Public works. DEPARTMENT

G.O. No. 3141 Press
~~B.P. No.~~ ~~Mis.~~
134-135

CIVIL WORKS, No. 15.

Collectors Cutcherry,
Treasury & Press Room
at Cocanada -

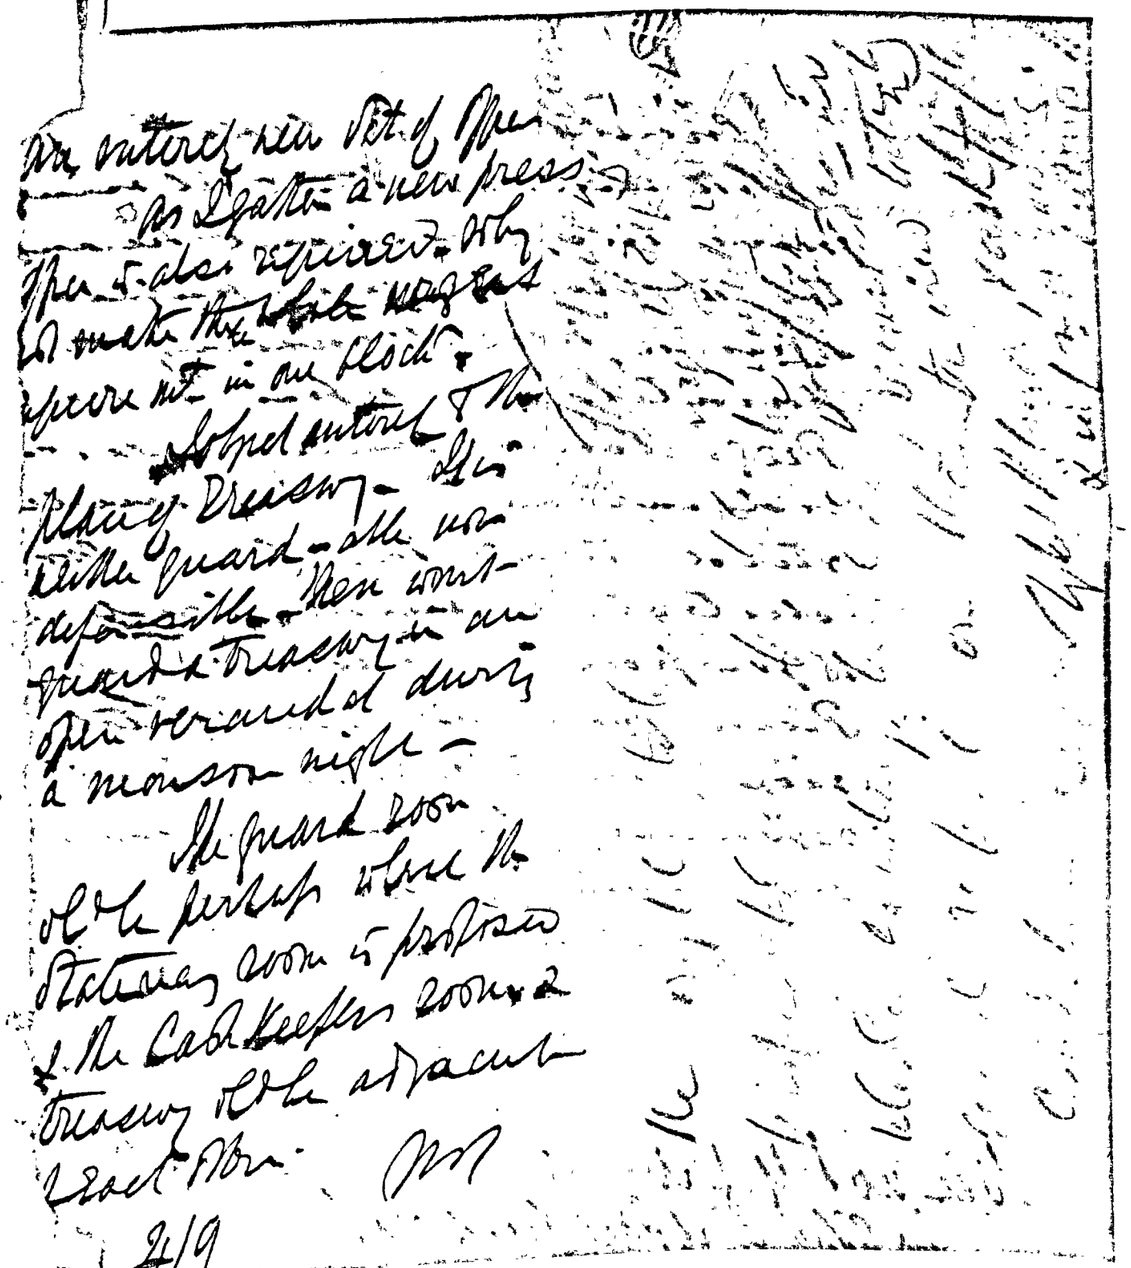
4. The plan of Treasury now submitted provides for a Treasury and Cash-keeper's office, each 40 feet by 20, one on each side of a room for stationery 20 feet square. But there is no proper accommodation for the Treasury guard; and the Cash-keeper's room is improperly separated from the Treasury.

5. The District Engineer is instructed to revise both plans and to throw them into one, submitting at the same time a plan of the whole of the existing buildings with report on their condition; and report on what is proposed to be done with the present Press and Treasury buildings when superseded by new ones. Meanwhile an entry of Rupees 20,000 on account of the work will be made in the Budget of 1875-76.
